DUNN FIELD
RECORD OF DECISION AMENDMENT

Defense Depot Memphis, Tennessee

Revision 3

January 2009

OFF DEPOT GROUNDWATER REMEDY

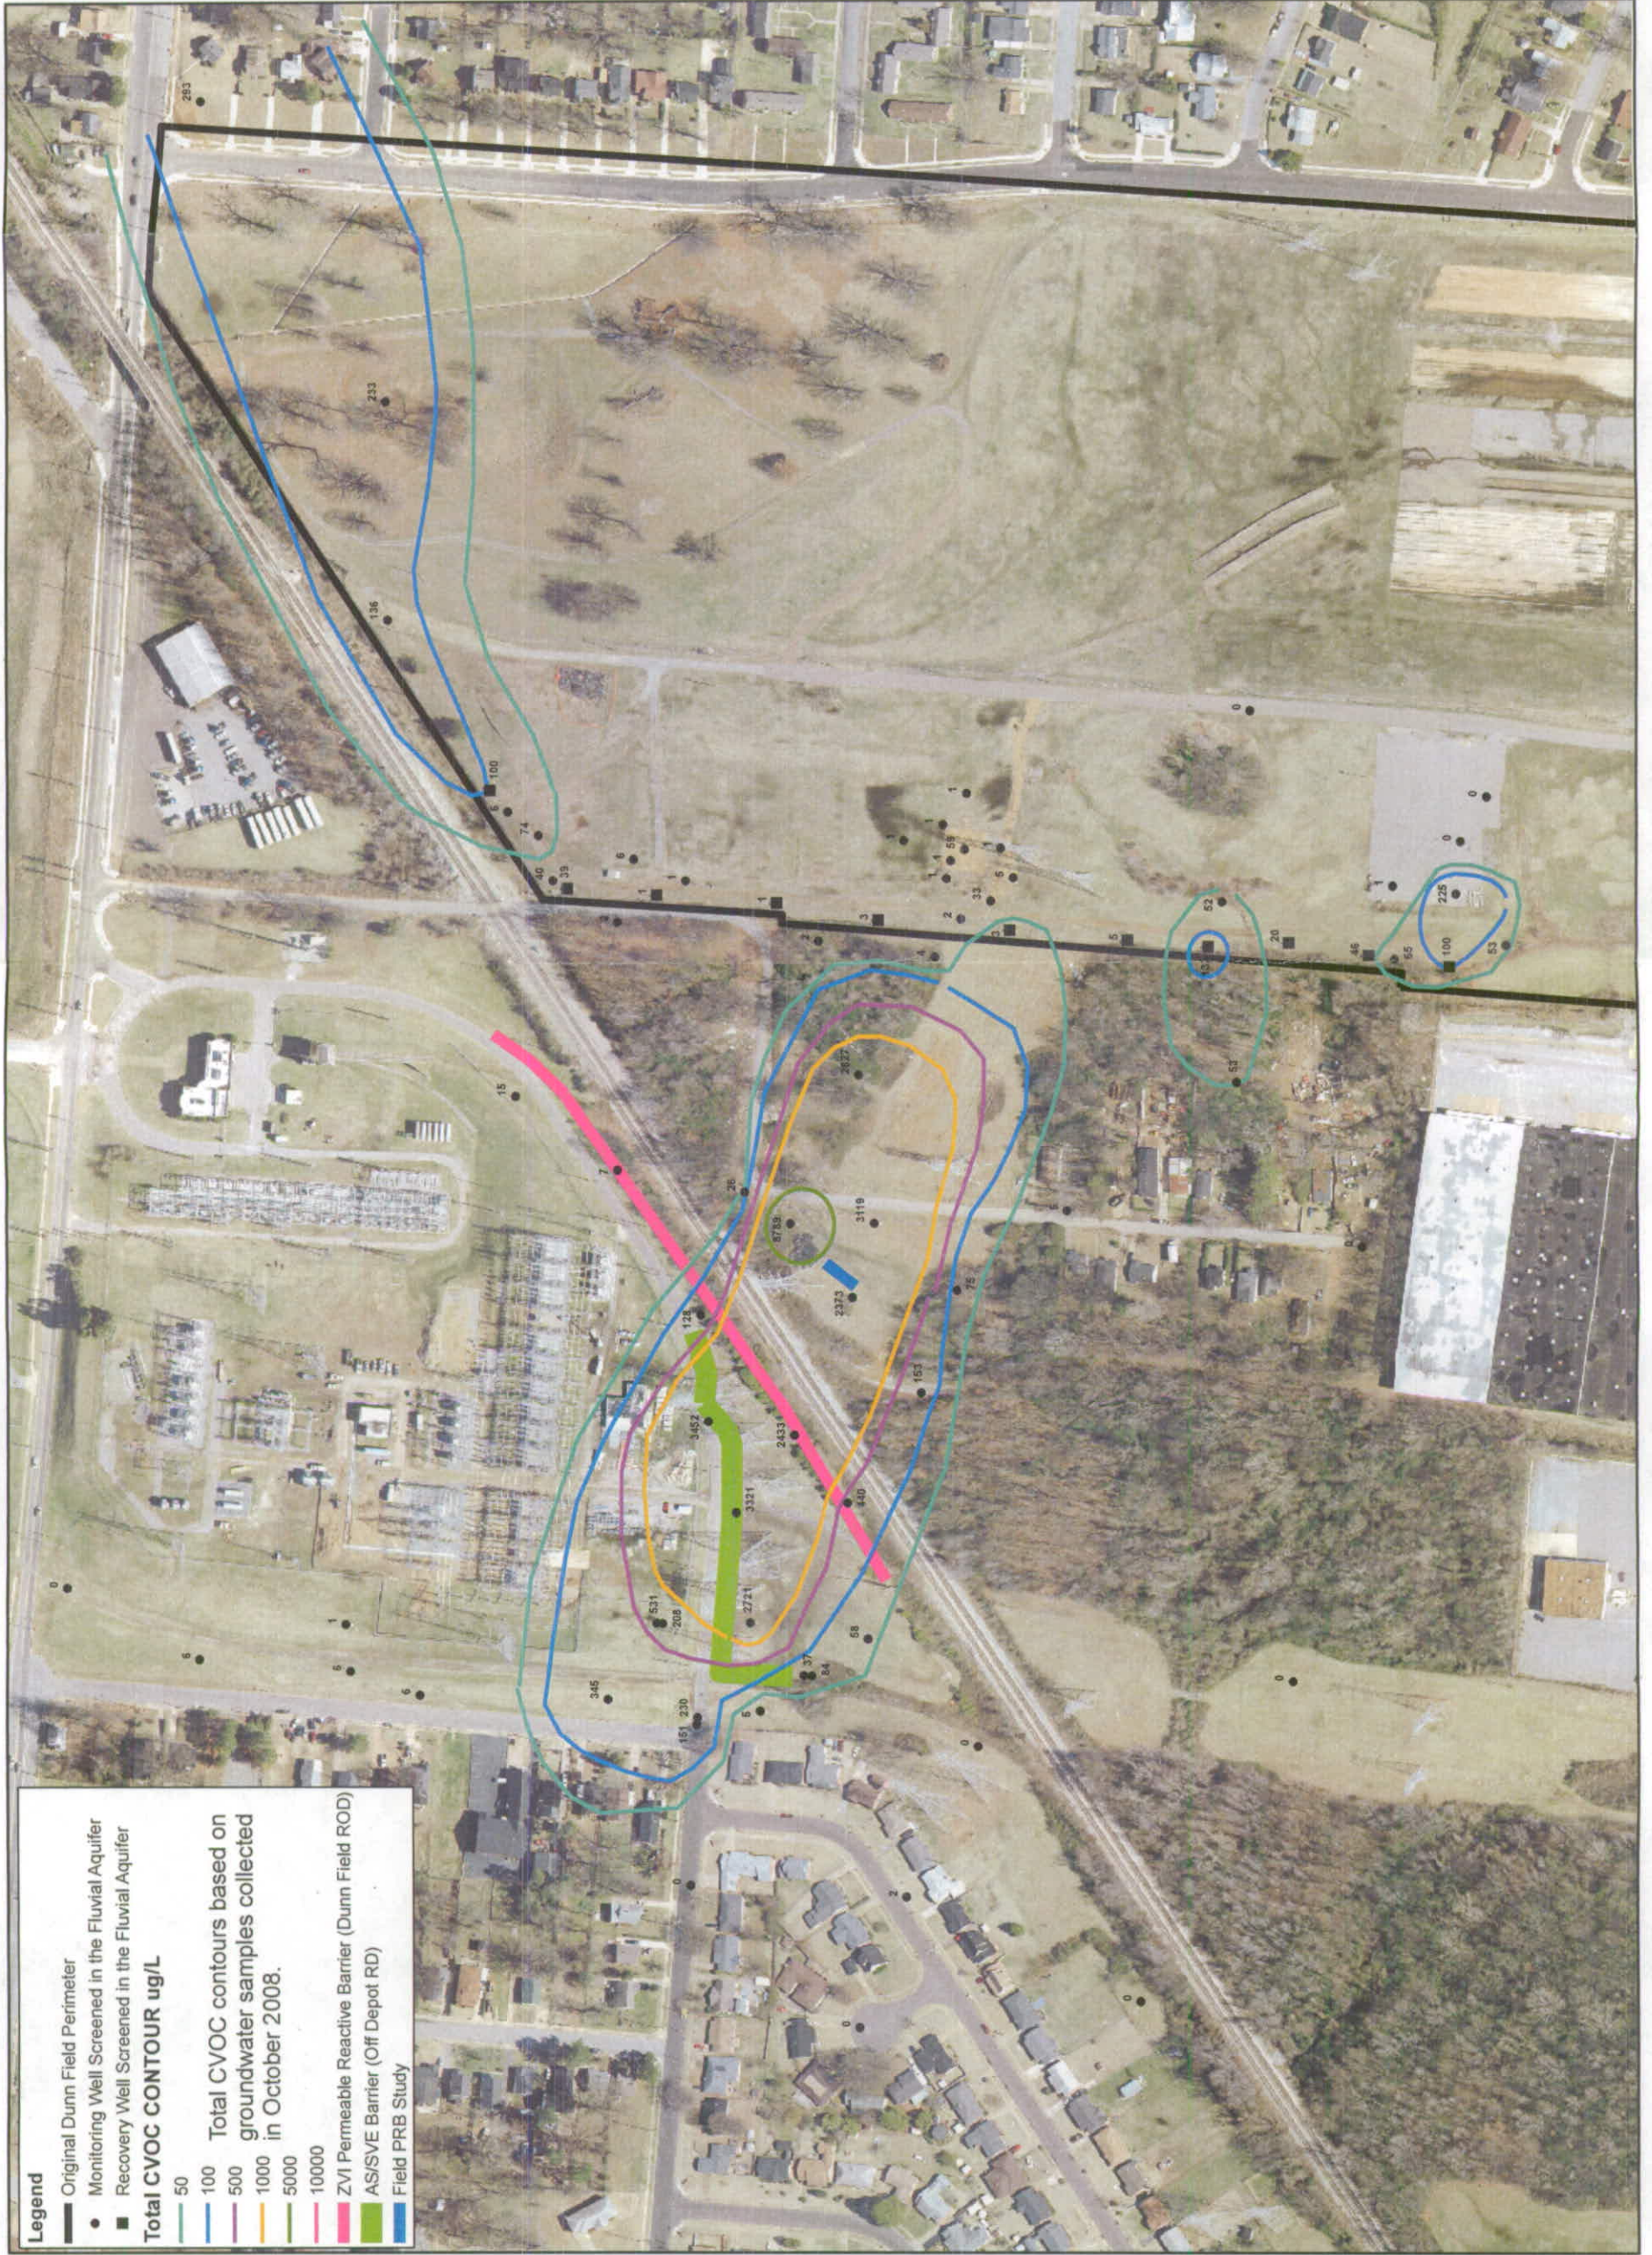
Additional monitoring wells installed for the EISR provided new information on groundwater flow gradient, saturated thickness, and contaminant concentrations around the ROD-proposed location of the ZVI PRB, shown on Figure 3. The relatively low groundwater gradient in that area would make it difficult to ensure consistent flow through a ZVI PRB, while the thicker saturated zone would increase the construction cost. In addition, concentrations of chlorinated volatile organic compounds (CVOCs) downgradient of the ROD-proposed location exceed 5,000 parts per billion (ppb), which is an order-of-magnitude higher than those identified at the time of the ROD. These concentrations are higher than considered appropriate for MNA and would require active treatment downgradient of the ZVI PRB.

The ROD stated that the length of the PRB would be based on the furthest northeast and southwest 50 ug/L isoconcentration contour for any COC. The extent of the recommended active remedy (AS-SVE), shown on Figure 3, crosses the core of the plume near the downgradient end. The MLGW substation prevents shifting the AS-SVE system further north to capture more of the plume. The criteria for the length of active treatment presented in the ROD were conservative to address the level of uncertainty on groundwater flow and contaminant transport. Studies completed since completion of the ROD have greatly reduced the uncertainty, and the planned extent of the AS-SVE system in combination with natural attenuation is considered sufficient to achieve groundwater RAOs.

The offsite granular iron PRB will be placed across the flow path of the VOC plume, as the plume flows through the PRB under natural gradients, the VOCs are destroyed to non-toxic end products. The PRB will be approximately 1,050 feet in length as shown on Figure 3. Untreated parts of the plume will degrade under natural attenuation processes. Groundwater monitoring will include monitoring of the PRB and the untreated parts of the plume with 43 monitoring wells, including 15 new wells. Groundwater monitoring will be performed over the cleanup time estimated to be approximately 15 years after remedial action implementation. The uncertainties noted in the ROD for this component were: (1) the vertical installation of the offsite PRB to depths of 100 feet below land surface; (2) the degradation rate of the VOCs through in situ chemical reduction and natural attenuation; and (3) the potential movement of the plume and the length of time required for cleanup.

The AS-SVE system will be installed to intercept the majority of the Off-Depot CVOC plume and reduce individual CVOC concentrations to below 50 µg/L. The approximate location is shown on Figure 3. The AS barrier will include approximately 78 vertical sparge points spaced at 15-foot intervals in two rows at the distal end of the plume along Menager Avenue. Twelve additional sparge points will be installed in the central portion of the AS barrier to address the core of the plume. Each sparge point will be installed at the base of the fluvial aquifer (90 to 100 feet bgs). Twelve SVE wells will be installed on approximately 50-foot centers to capture the vapors from the AS wells. Each SVE well will include a 30-ft screened interval, generally extending from 35 to 65 feet bgs. The final locations of the individual AS and SVE wells will be based on the results of additional groundwater sampling events and site access.

Figure 4
TOTAL CVOC
CONCENTRATIONS,
TIME TREND

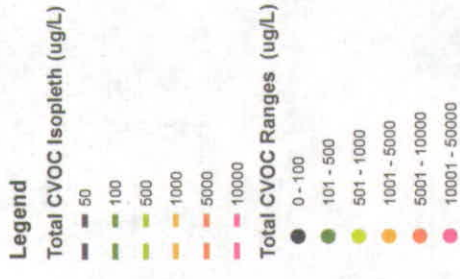
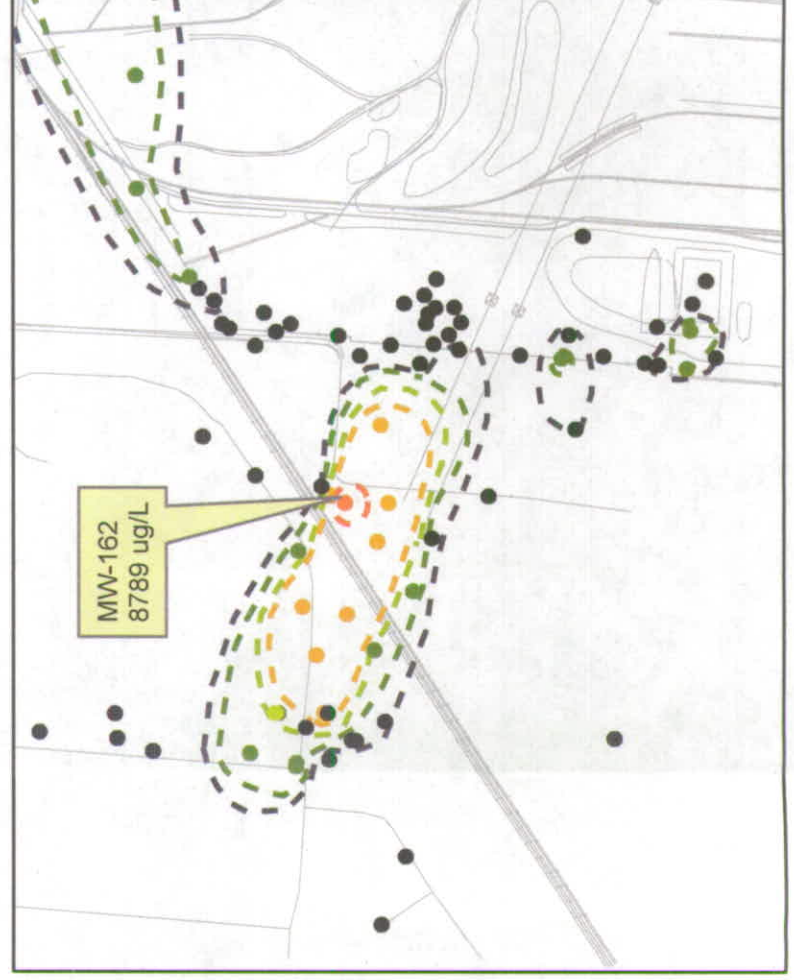
Thirty-one new monitoring wells were installed in 2004 in the Off Depot area to determine the extent of the groundwater plume. Groundwater monitoring results since 2005 (Figure 4) demonstrate that the overall plume extent has been stable since that time. Groundwater modeling conducted for the Off Depot RD suggests that while the AS-SVE system will reduce CVOC concentrations in the fluvial aquifer, the system is not needed to protect the Memphis Sand aquifer. Estimated CVOC concentrations in the Memphis Sand aquifer are well below maximum contaminant levels with or without the AS-SVE system. Based on groundwater monitoring results since 2005 shown on Figure 4, operation of the Fluvial SVE system on Dunn Field has greatly reduced groundwater concentrations upgradient of the AS-SVE system location.

Figure 5

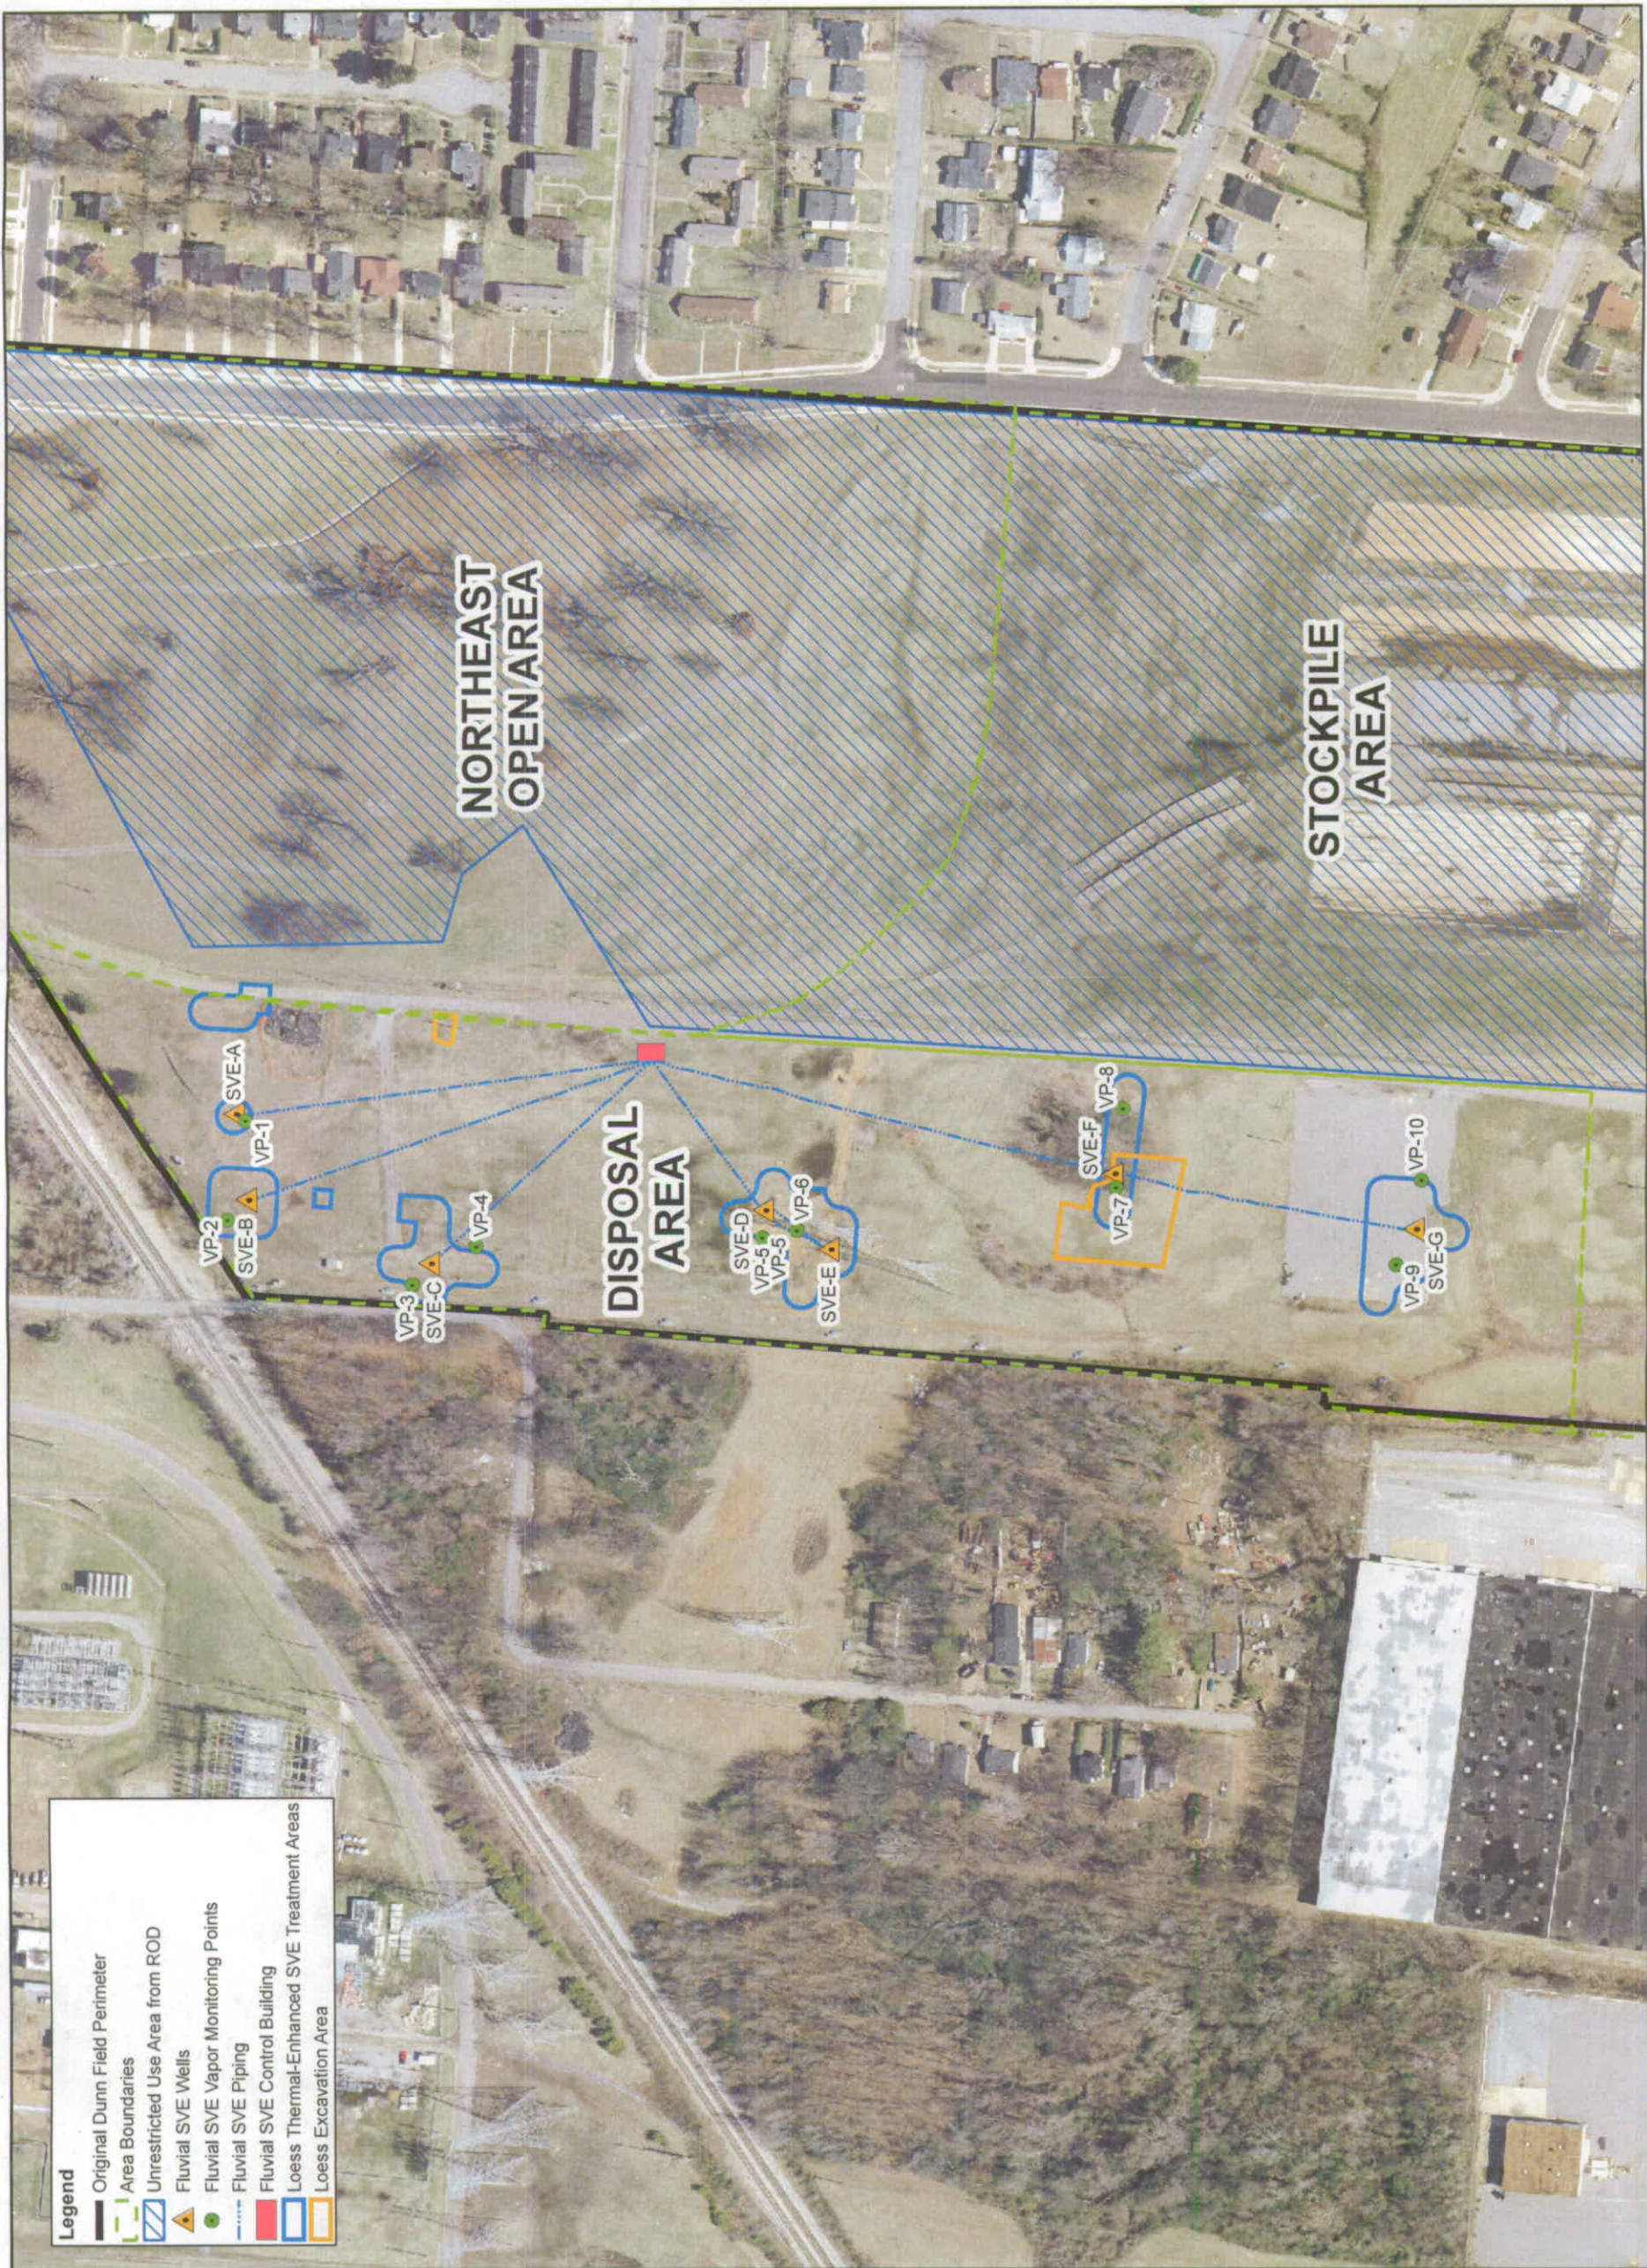
The revised loess treatment areas and the excavation areas are shown on Figure 5. The highest CVOC concentrations in the fluvial vadose zone are assumed to be directly below the highest CVOC concentrations in the loess; the fluvial SVE layout is also shown on Figure 5.
